MEMORANDUM

Subject: **Memorandum - Approval of Budget Amendment to Dunwoody Nature Center Stormwater Project**

Request from Council to approve budget amendment for micropool extended detention (ED) pond project located at the Dunwoody Nature Center (North Woods Pavilion).

MODIFIED FOOTING & WALL DETAILS

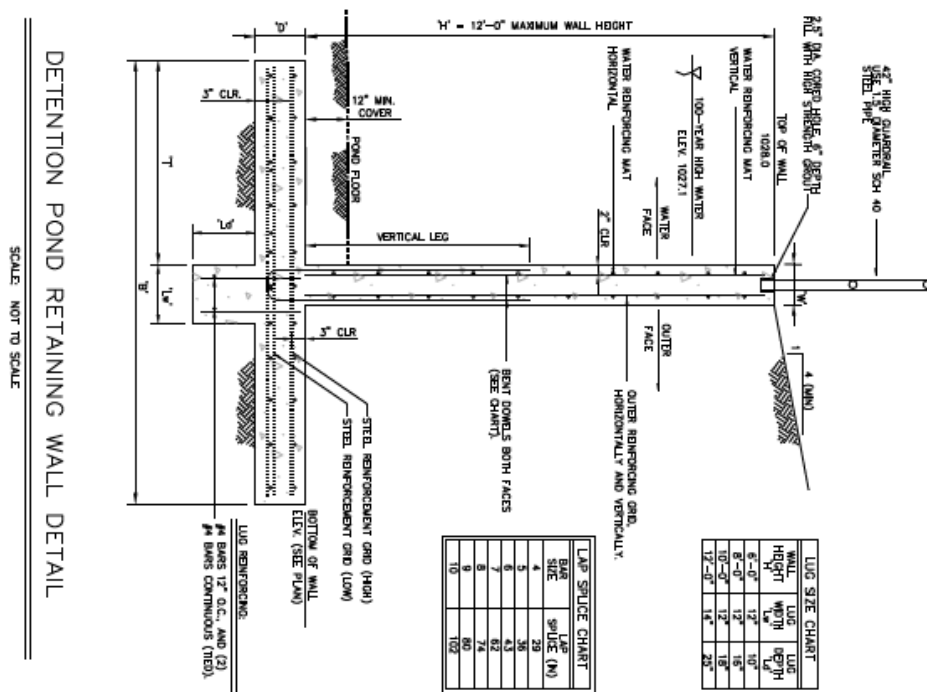
- In-field modifications were made to the pond. After observing the performance of the pond during multiple rain events, it was determined that design modifications were required to ensure the pond retaining wall would not collapse or slide during larger storms. Wall design alterations were completed in June, and added an additional \$19,993.68 to the project cost. **Despite alterations, the pond is within budget at a current cost of \$216,921.68.**

MICROPOOL (CURRENT CONDITION)

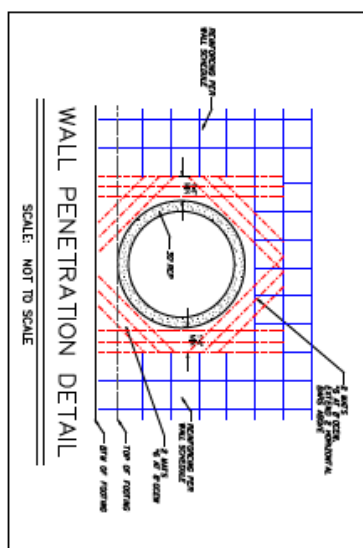
- It was observed during drier conditions that the micropool would dry out within a few days. Slower infiltration increases the pollutant removal capabilities of a micropool. A permanent pool also adds an aesthetic component to the pond as well. Staff decided that adding bentonite, a fine-textured clay with a much slower infiltration rate than standard soils, would be a viable solution. **If approved by Council, the additional cost for bentonite installation is \$6,629.70.**

Staff recommends approving the amended budget for the construction costs of the Dunwoody Nature Center micropool ED pond from the corrected quote of \$219,046.30* to \$223,551.38.** Staff recommends funding remaining \$6,629.70 (with 10% contingency), for bentonite installation in the micropool, out of the Stormwater Reserve Fund.
